UNITED STATES
DEPARTMENT OF THE INTERIOR Bureau of Land Management
BUREAU OF LAND MANAGEMENT Farmington Field Office

SUNDRY NOTICES AND REPORTS ON WELLS
Do not use this form for proposals to drill or to re-enter an abandoned well. Use Form 3160-3 (APD) for such proposals.

Black Hills Gas Resources intends to plug and abandon the Many Canyons 30-04-24 #34 per the attached procedure; dated 3/3/2010

Re: Permanent Abandonment
Well: 34H Many Canyons 30-4-24

Proposed P&A

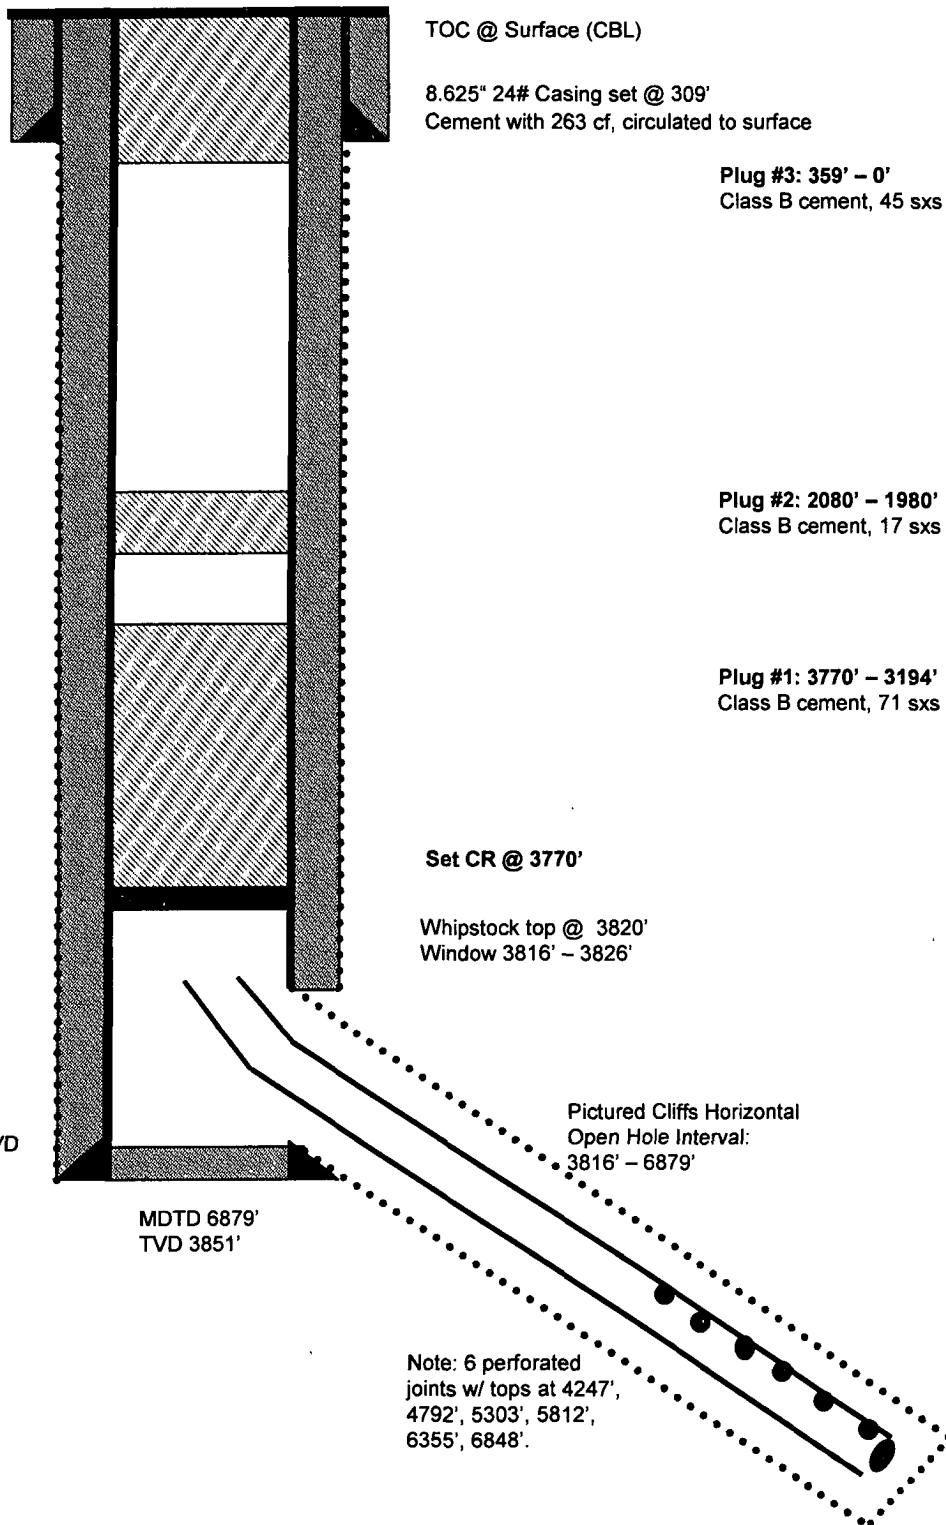
1. Plugging operations authorized are subject to the attached "General Requirements for Permanent Abandonment of Wells on Federal and Indian Lease."
2. Farmington Office is to be notified at least 24 hours before the plugging operations commence (505) 599-8907.
3. The following modifications to your plugging program are to be made:
 - a) Bring the top of the Pictured Cliffs/Fruitland/Kirtland/Ojo Alamo plug to 3183'.
 - b) Place the Nacimiento plug from 2109' – 2009'.
 - c) You are required to have H2S monitoring equipment and personnel on location during plugging operations.

You are also required to place cement excesses per 4.2 and 4.4 of the attached General Requirements.
